Groundwater Transfer Review Summary Form

Transfer/PA # T- 14764

Application: T-14764

Applicant Name: Threemile Canyon Farms

Figure 2. Well-to-well interference estimates, using the Theis model (1941), show less than one foot of increased drawdown at a nearby well resulting from pumping at the proposed APOA (Johnson 1R at 2,800 feet away vs pumping UNIO 1199 at 3,000 feet away).

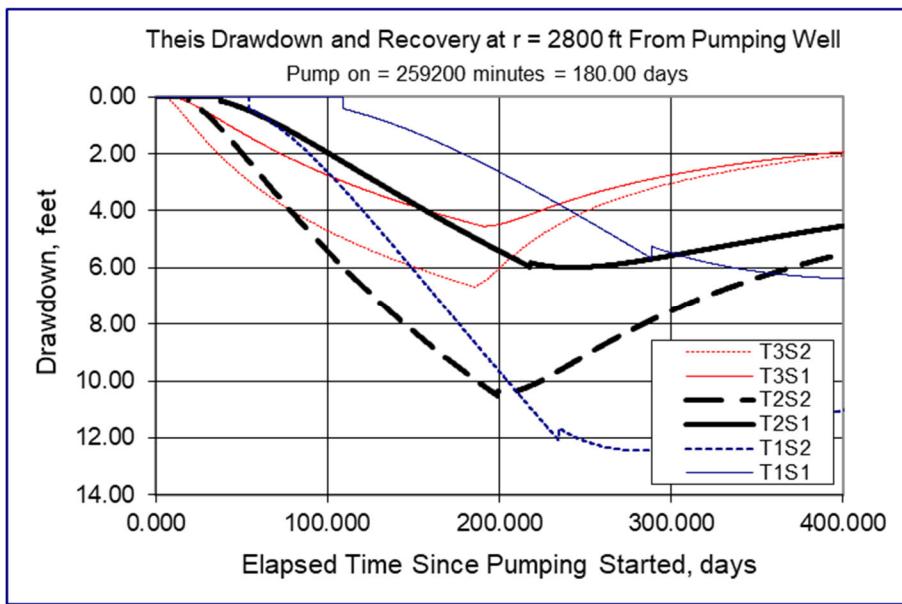
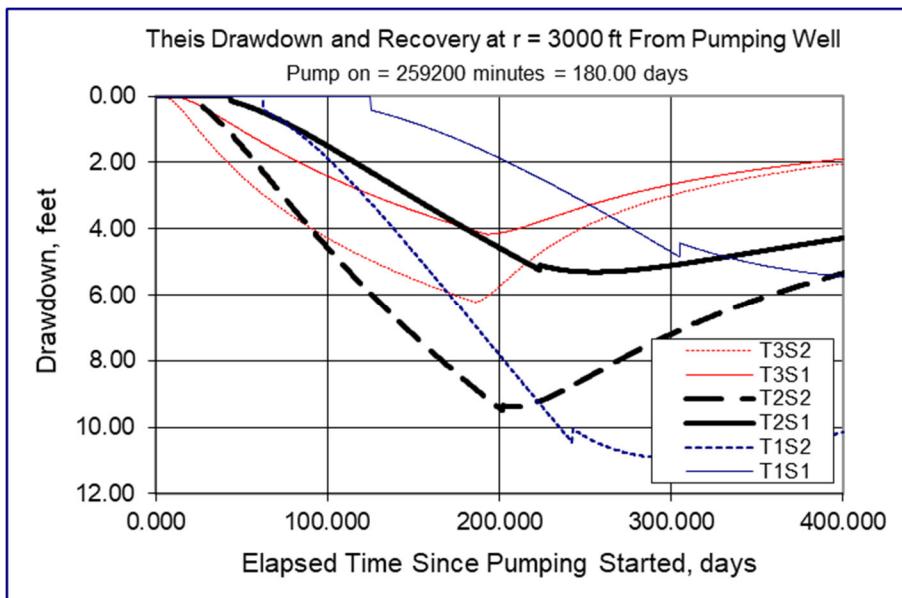
Yes No If yes, explain: Moving pumping from UNIO 1199 to Johnson 1R will result in less than one foot of additional drawdown at nearby UNIO 1209 (see Figure 2), based on Theis distance- drawdown estimates using pump test data from nearby wells (pump test data from UNIO 51275, 51431, 2574, 1198, 1166, 51274 were analyzed to identify the local range of alluvial aquifer parameters). This will not prevent access to groundwater at UNIO 1209, which is 345 feet deep with over 300 feet of water in the well.

Figure 3. Stream depletion impacts to Ladd Creek modeled using Hunt (1999) show no change resulting from the APOA and POA changes proposed by this transfer application.

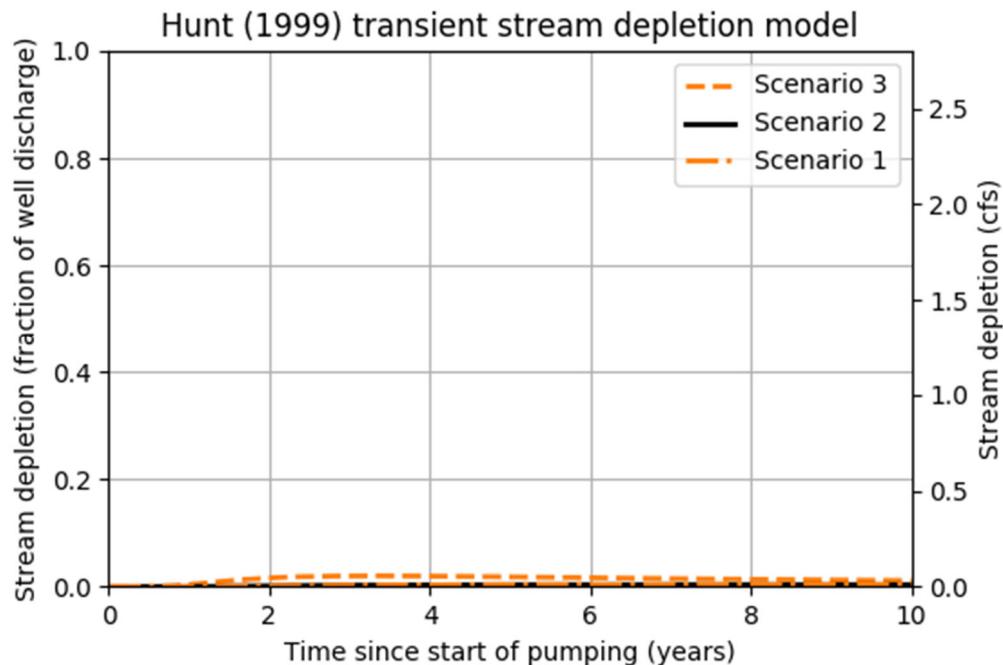
Yes No Comments: The nearest stream is Ladd Creek, located more than 2 miles away from the subject wells. Johnson 1R will be approximately 200 feet closer to the creek than UNIO 1199, which is will not change stream depletion estimates (Hunt, 1999; see Figure 3).
